**UPDATE!**  
**Notice of Public Hearing**  
**Redevelopment – Northwest Corner of Laurel and Western Avenues**

**Building Review Board**  
**Meeting Date: Wednesday, September 2, 2015**  
**Meeting Time: 6:30 p.m.**  
**Meeting Location: City Hall Council Chambers – 220 E. Deerpath**

**Agenda Item 4**  
**Laurel and Western Avenue Redevelopment**

**Laurel and Western Avenues Property Redevelopment – Development Parameters**

PREVIOUS DESIGN - JULY 2015

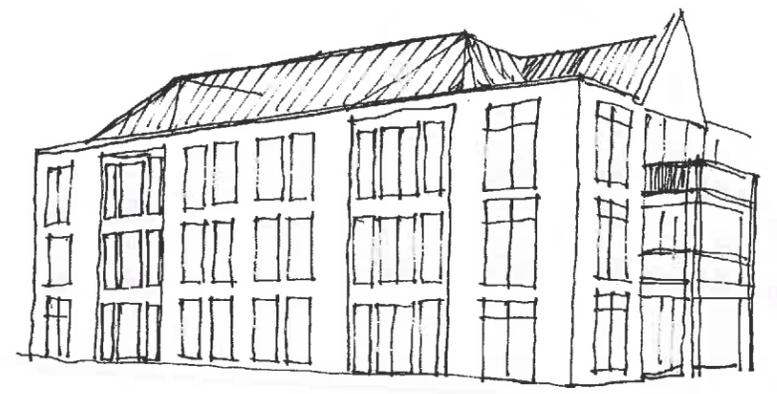
Feedback: Buildings appear monolithic and not enough variation between apartments and condominiums.

Feedback: Study the roof forms and provide more distinction within the roofscape.

Changes: All building heights were reduced and different brick colors were introduced to further distinguish the buildings.

Changes: Lowered the middle section on all apartment buildings and introduced dormers. The roof form breaks down the mass of the building and further reduces the scale of the buildings.
